**FINAL REPORT
VALUE ANALYSIS STUDY**

**PIMA ASSOCIATION OF GOVERNMENTS
RTA Silverbell Road
Value Analysis Project**

November 2011

BY SOLUTIONS ENGINEERING & FACILITATING, INC.

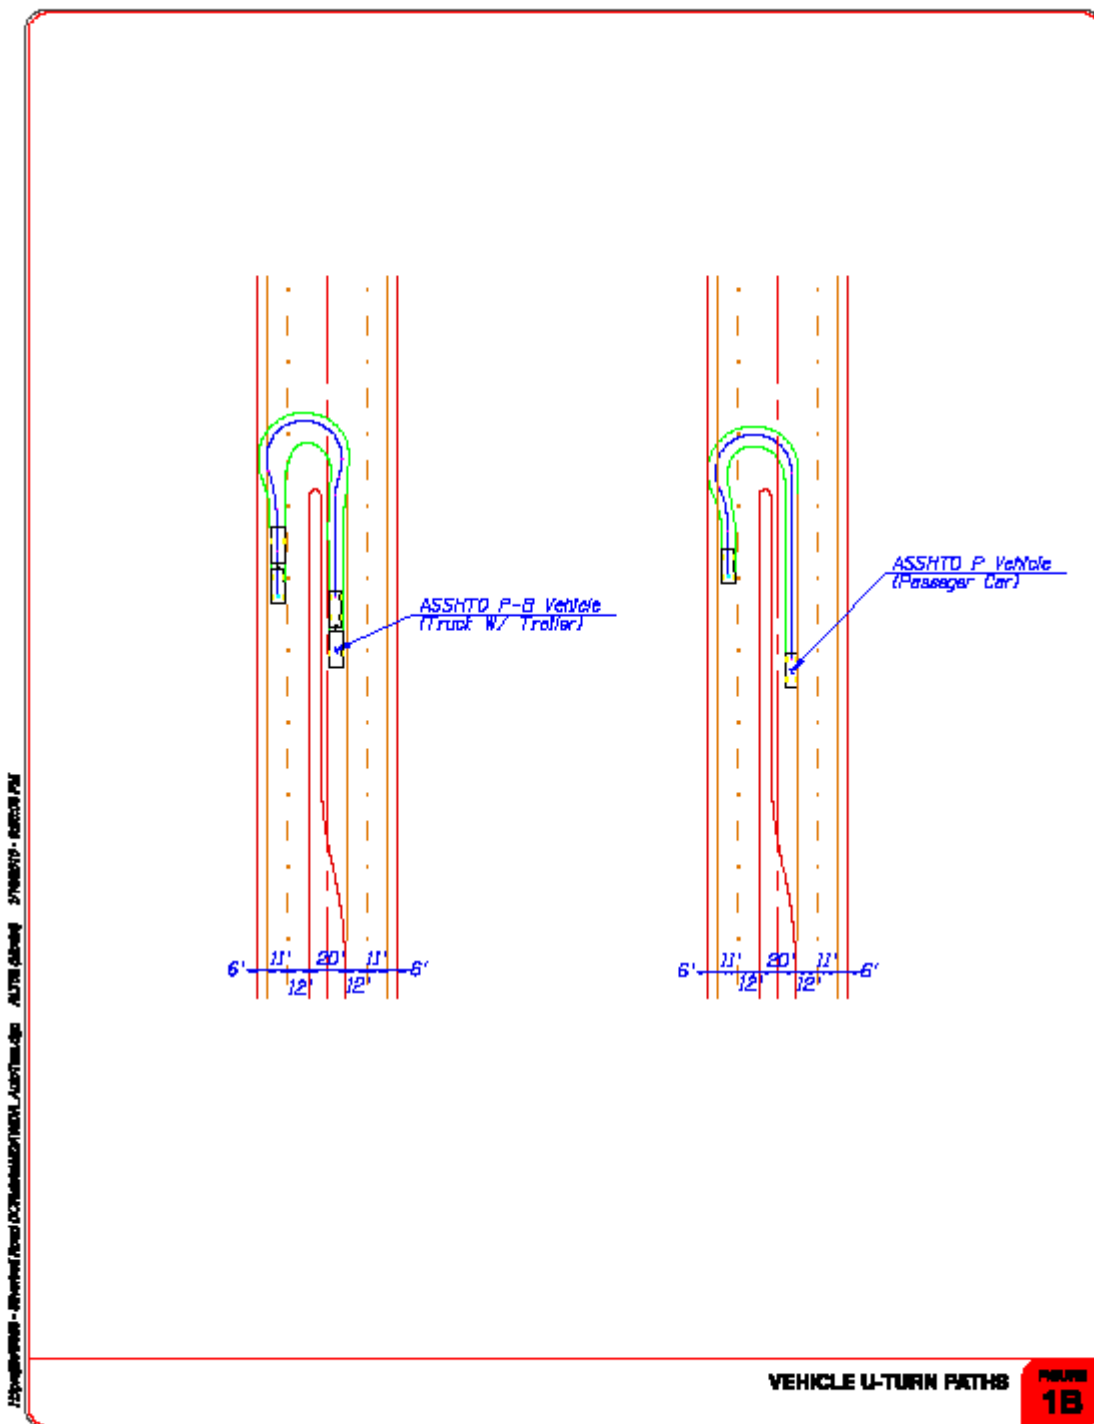
The current median width is 20' wide. The median width can be reduced by 4' and still allow a left turn lane (10') with a raised median nose (6') and not require the roadway geometry to hour-glass between median openings. Additional loon pavement will be required in this condition to allow for u-turns at median openings.

The savings from reducing the median will come from reducing the amount of fill in areas where the roadway is being raised. The attached diagram illustrates the length of the roadways where this savings can be applied.

South - Neosha to Del Cerro - 10,500 ft long, 4' high fill
 North 1 - Del Cerro to Sunset - 5,900 ft long, 7' high fill
 North 2 - Sunset to Belmont - 10,000 ft long, 4' high fill

Area Map

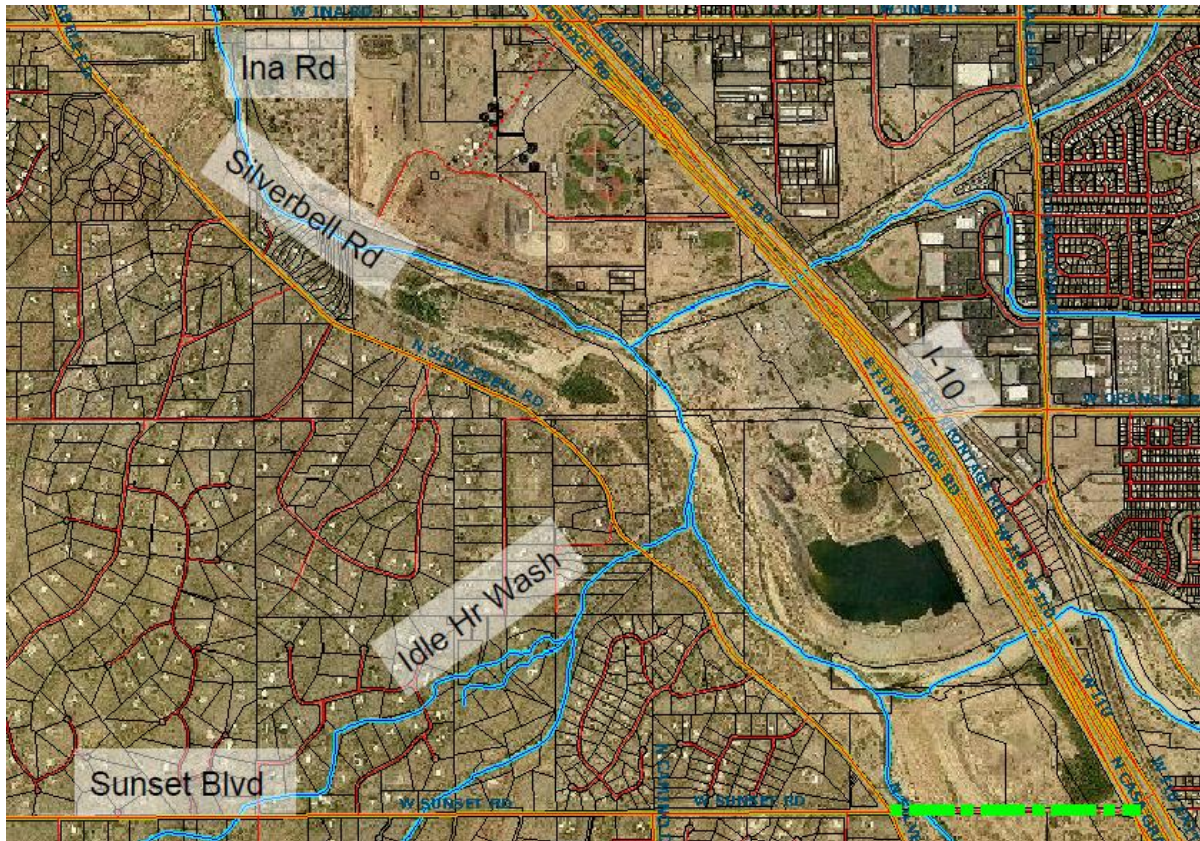
The project plans show two very large culverts at Idle Hour wash, a 5-cell 12'x10' box, and a 2-cell 12'x8' box. Normally those structures would be constructed in two or more phases to keep the roadway open to traffic. However, that strategy increases labor and traffic control costs, and lengthens the schedule.

Another alternative would be to provide a paved detour around the construction of the culvert, which would still provide the labor savings. The cost of the detour (width = 24') would be approximately \$17/lf x 500 ft = \$8,500. Resulting savings would still exceed \$100,000.
